Project: 226052 DFCI-BIDMC New Cancer Hospital - 1 Joslin Place - Construction
1 Joslin Place
Boston, Massachusetts 02215

RFI #0-PB-94: Generator Panelboard Power

ELECTRICAL EMERGENCY RISER DIAGRAM #2

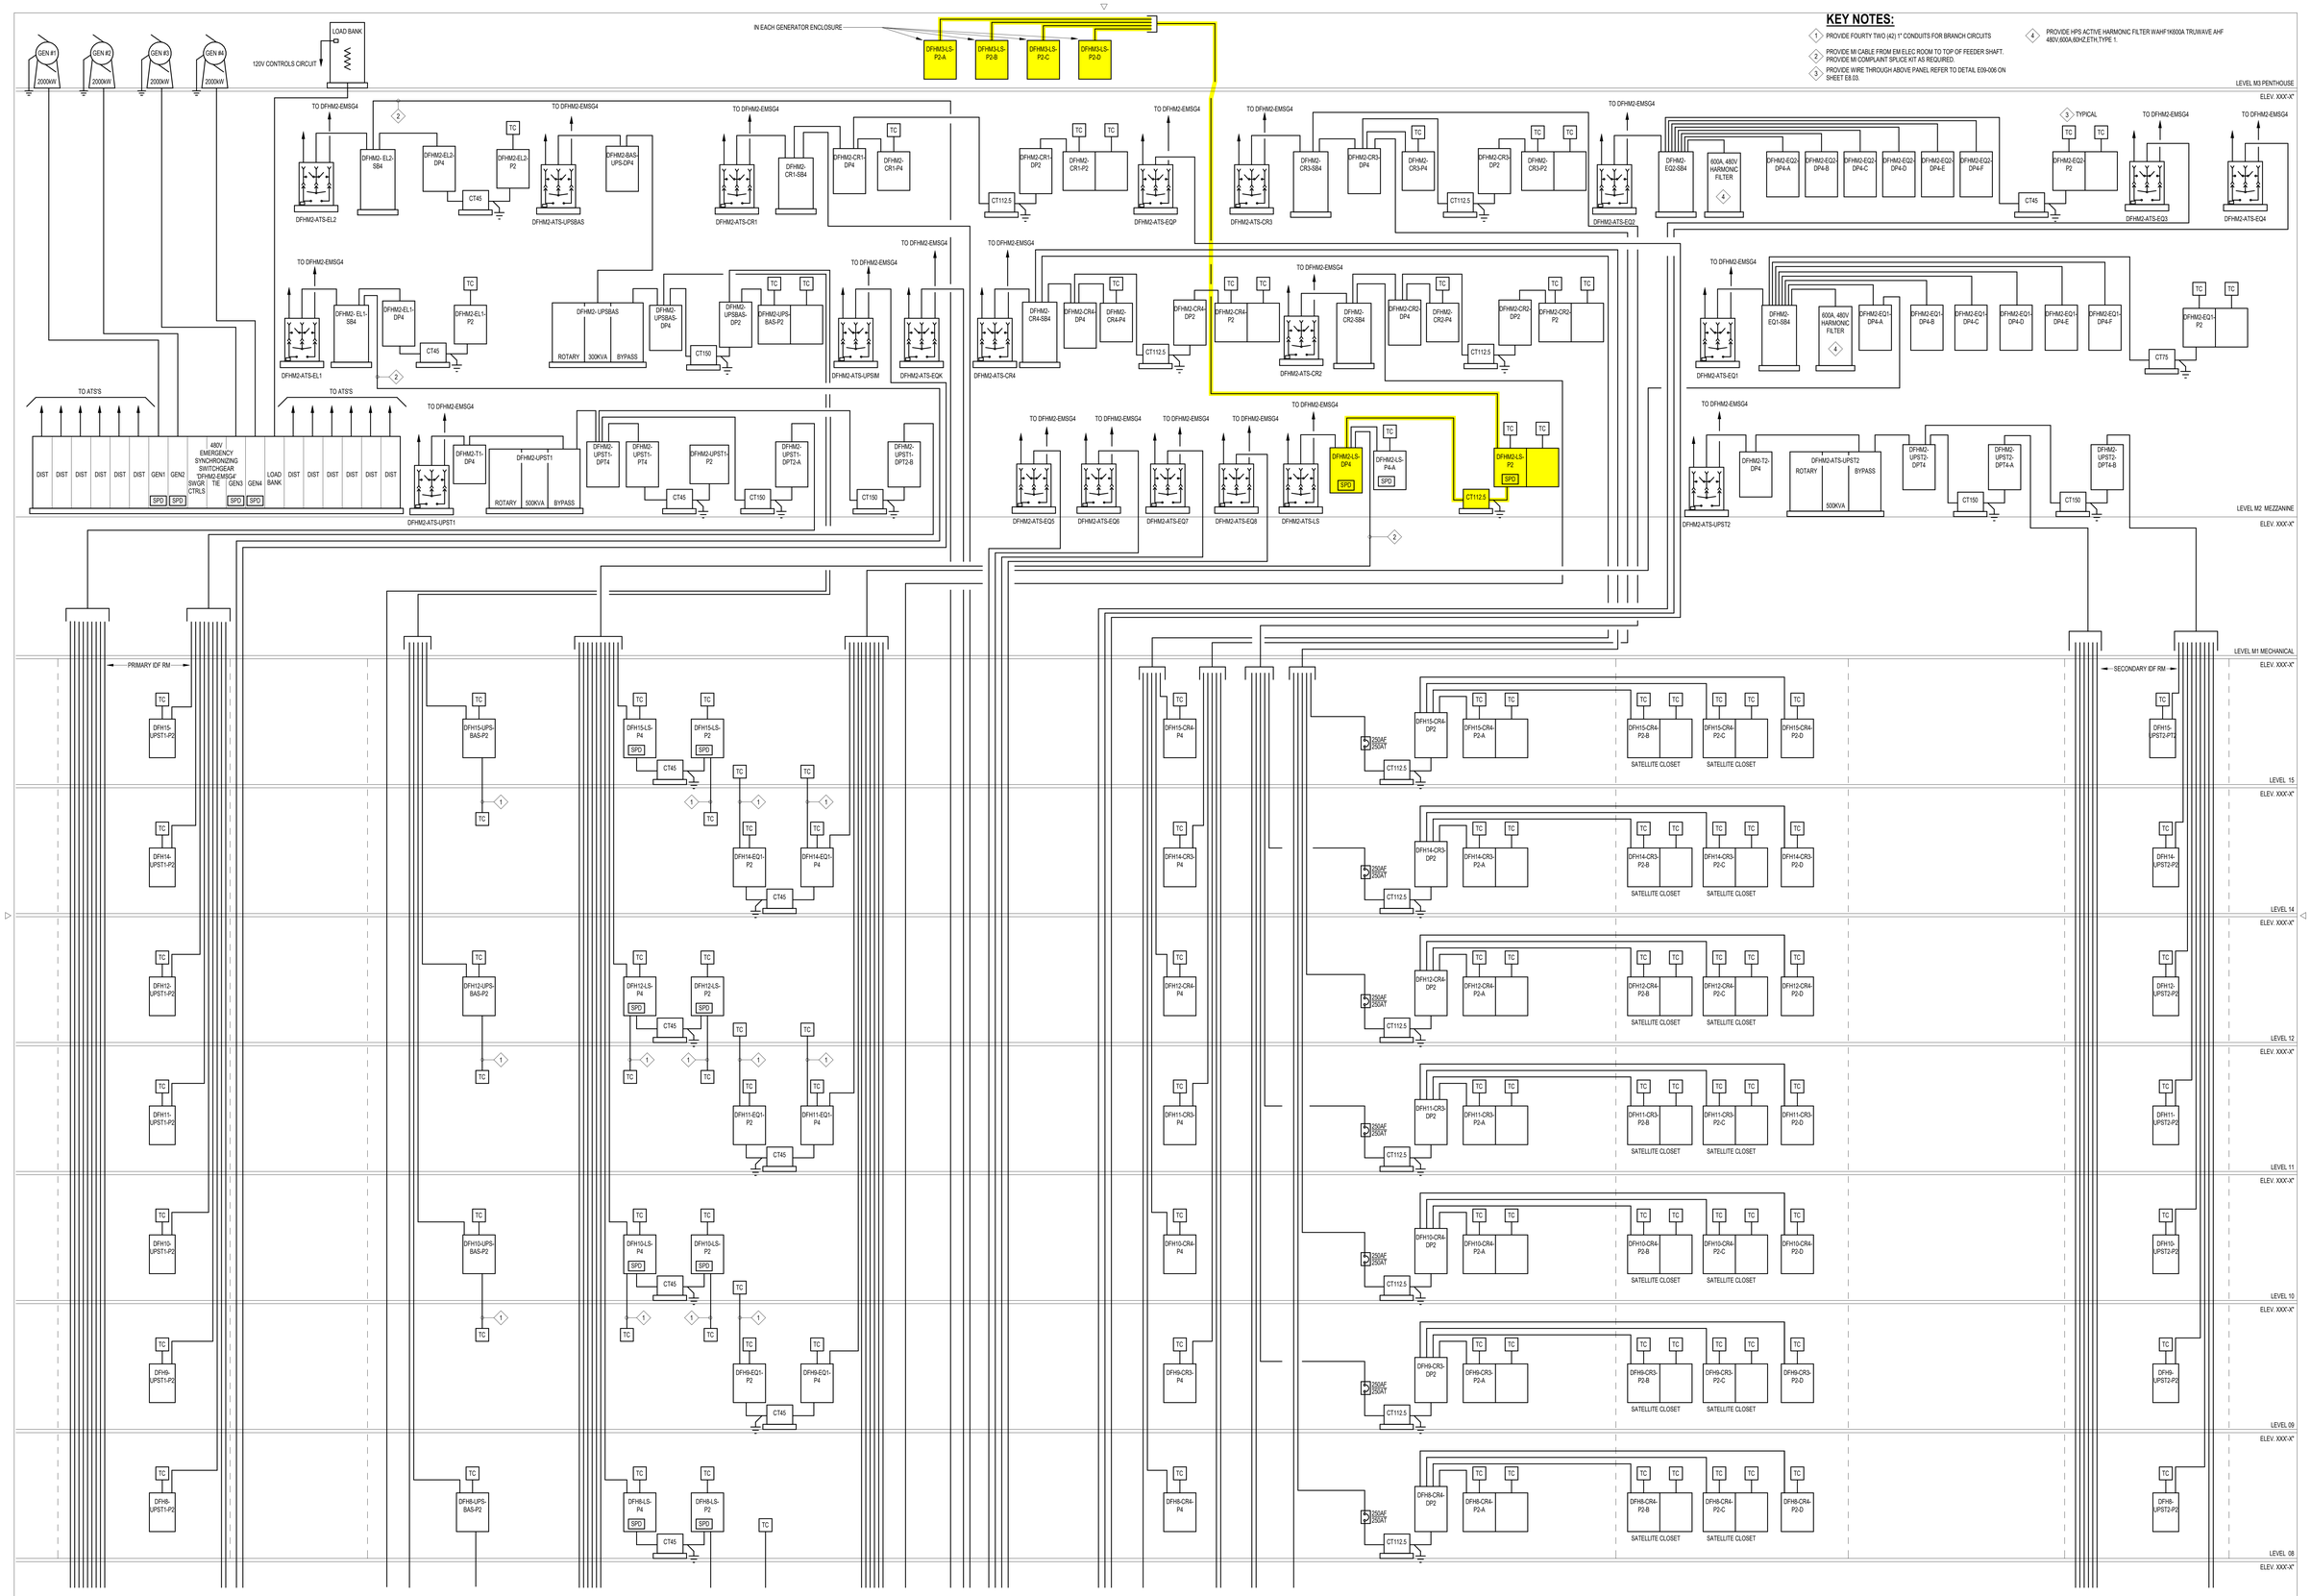
The 208/120V panelboards for each of the (4) generators are to be provided with a 150A MCB per Specification 263010 Section 2.2O.1. and the E7.502 panelboard schedule. All (4) panelboards are fed by DFHM2-LS-P2, which is shown as a 150A MCB panel, however it is served by a 112.5 kVA transformer. The transformer's primary OCPD is shown as 150A via DFHM2-LS-DP4. The E7.01 transformer schedule shows 112.5 kVA transformers with 250A primary OCPD and 400A secondary OCPD. Please clarify feeder and OCPD sizes associated with power to the generator panelboards.

Per Payette 12/2/2025 response: Panel 'DFHM2-LS-P2' shall be a 400A MCB. The primary circuit breaker in DFHM2-LS-DP4 is circuit #1 (250A) not circuit #2 (150A). Load name will be updated in the 1/15 Addendum. Generator panels shall stay as 150A with C150Y feeder tag (4#1/0 & 1#6G - 2"C).
